<b>Permit Type</b> Building/Residential/Alteration/SFD	<b>Permit Number</b> B21000052	<b>Opened Date</b> 01/08/2021
---	-----------------------------------	----------------------------------

FINISH AND INSULATE 264 SF BREEZEWAY FOR NEW MUDROOM, LAUNDRY ROOM AND GUEST BATH. ADD 86 SF TO BREEZEWAY FROM GARAGE. DEMO GARAGE STAIR AND RECONFIGURE. INSULATE ROOM ABOVE BREEZEAWAY. INSTALL NEW HVAC UNIT TO SERVICE SECOND FLOOR. ADD MINISPLIT UNITS IN REC ROOM AND SALON. ADD BATHROOM TO BASEMENT. REPAIR ANY WATER DAMAGE AND MITIGATE WHEREVER NECESSARY. REBUILD STAIR IN BREEZEWAY AND IN MAIN HOUSE.

PROJECT TITLE  
**THE HAMMOND RESIDENCE**  
 12741 Folly Quarter Road  
 Ellicott City, MD 21042

**From:** Oswald, Hank  
**Sent:** Wednesday, January 27, 2021 10:08 AM  
**To:** Williams, Jeffrey  
**Subject:** Re: B21000052\_12741 Folly Quater Road

**1 SECOND FLOOR PLAN**  
 A102 SCALE: 1/4"=1'-0"

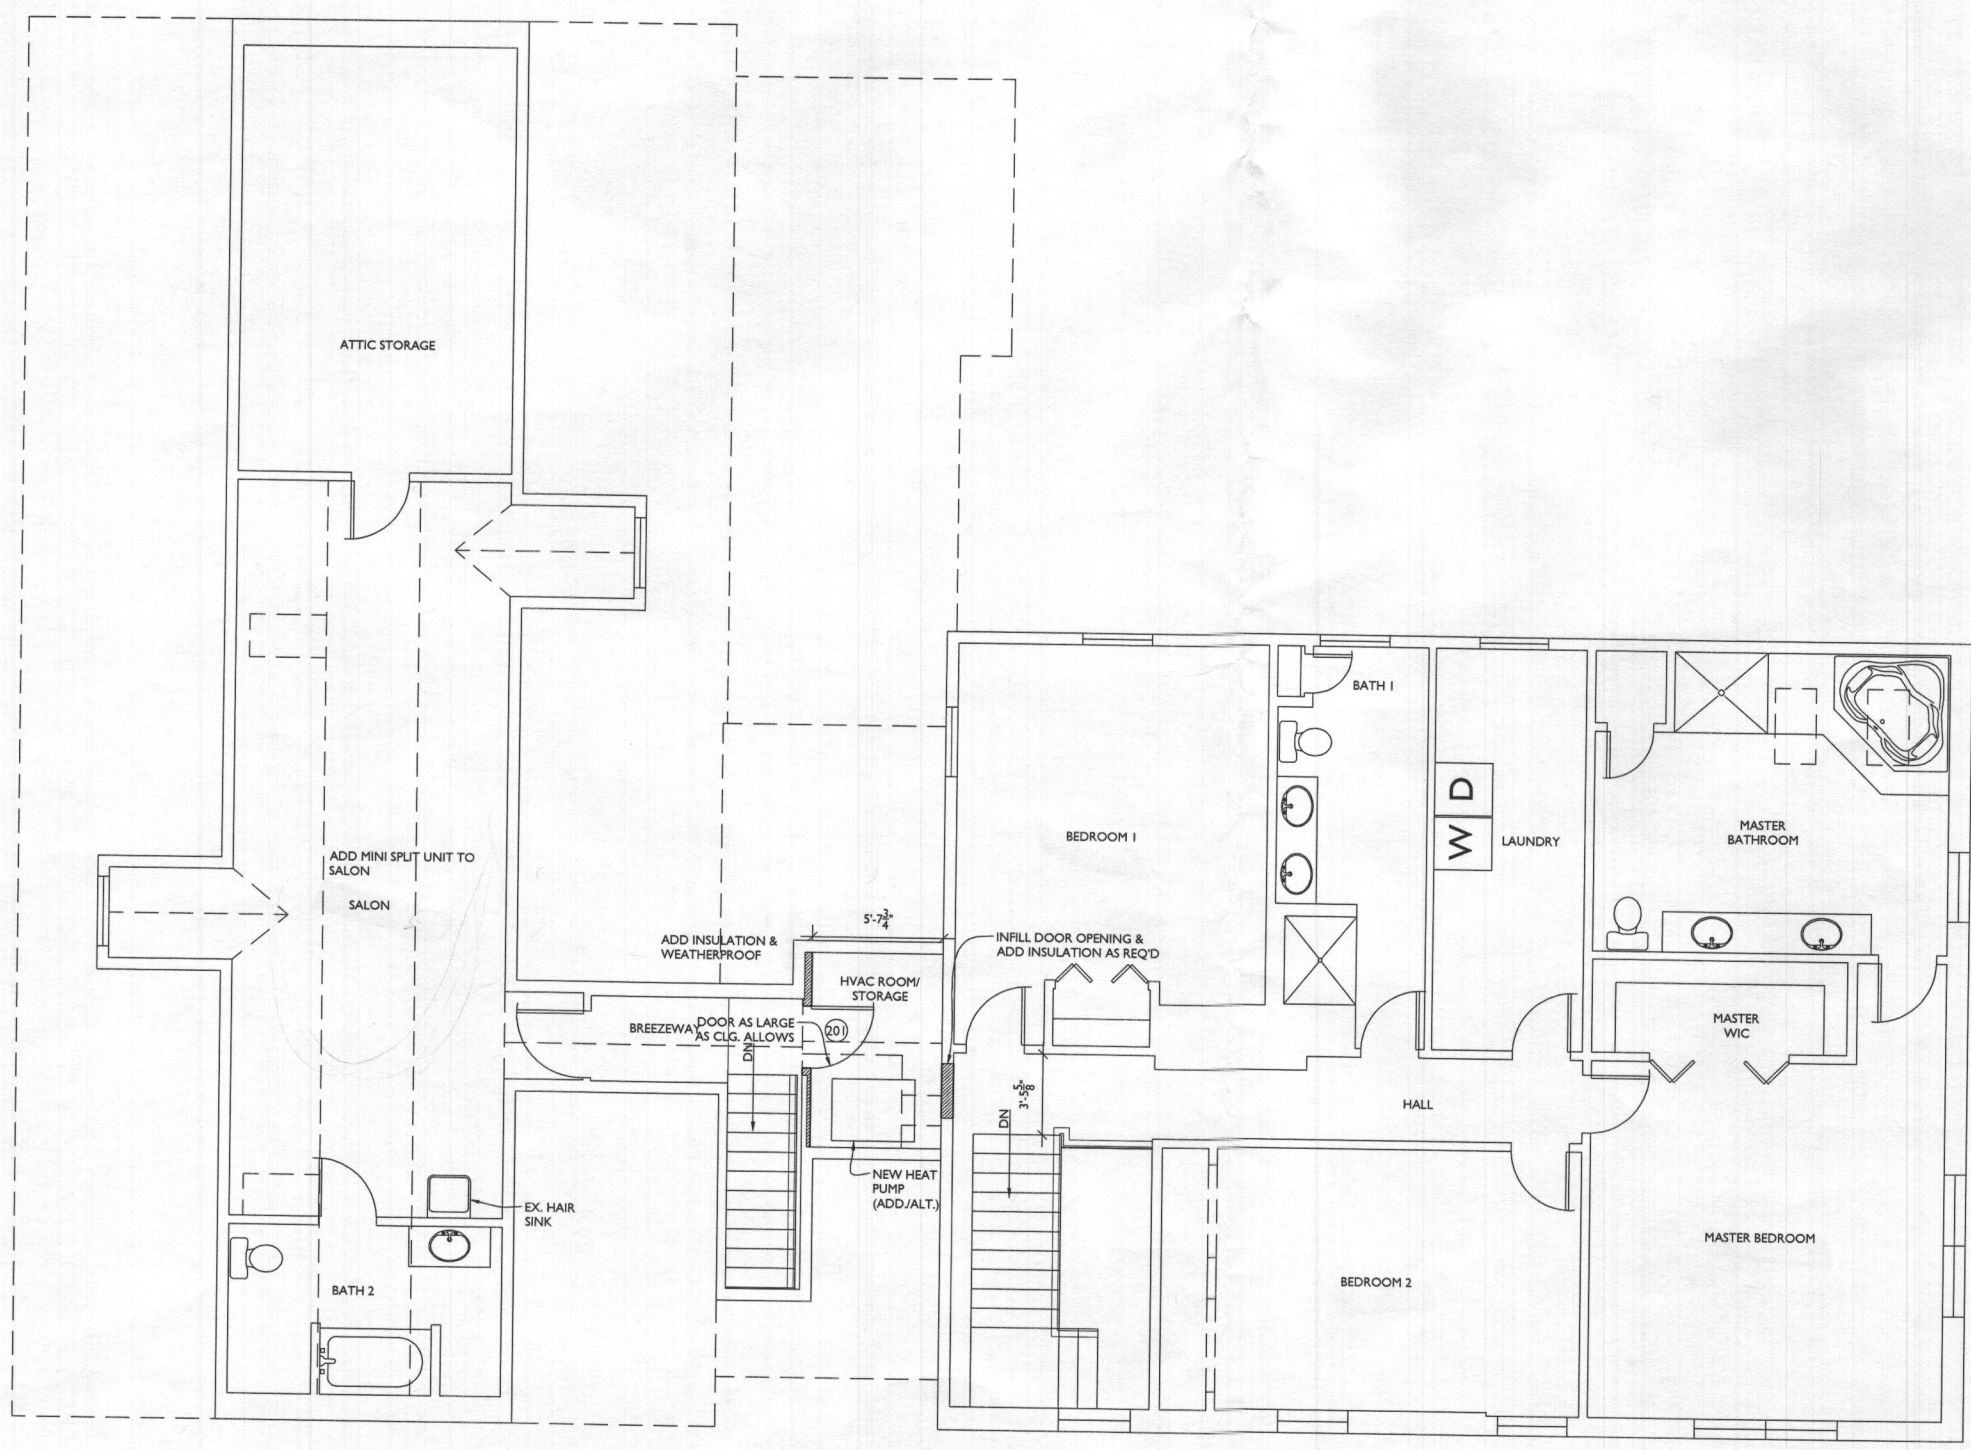
I thought I sent you the septic record with my questions about this BP, but I only see a reminder to myself. I guess I never sent it. The salon would count as a bedroom since it has a window, a door and direct access to a full bathroom. Who do I contact at DILP to get a ruling on this? I attached the septic record for your review.

Would the salon room count as a bedroom otherwise based on layout? I think we would need a ruling from DILP saying that they are ok to keep the equipment for personal use only. If so, they should submit to us a letter stating that they are only using it for personal use and they understand they will need to submit a BP for change in use if they intend to use it for customers (depending on what DILP says about it being there at all).

If the room could count as a bedroom, a compromise could be to put it at 150 gpd flow. The regular flow for a salon station is 250 gpd per MDE (that's at a commercial establishment). I think we need to account for the flow in some way.

We spoke about the BP for 12741 Folly Quarter last week. The applicant states that there was a salon, but it's no longer in use except for friends and family. The hair wash station and drying station are still operable. Do we still count it as a salon or bedroom? Did you get a chance to look over the record? I just need to know what to tell her. I think the revised floor plan showed 4 bedrooms and the salon with FB. The record contains perc test notes and an area (I sent you the record in a separate email last week). The percs went to 13.5 feet. Is that sufficient depth to certify the existing system? Is there enough info in the record for a perc cert plan? If not, then this is the list back to them.

I have a question regarding the renovation for 12741 Folly Quarter Road. Is there a salon business in this home?

Good morning. There was a salon business in the house at one time but it is no longer in use except for with friends and family. Shari is now a real estate agent and uses the space as her home office. We labeled it as a salon so that you would know it is NOT a bedroom. It does have the hair wash station and drying station still operable. I hope that answers your question. Let me know if you have any others.
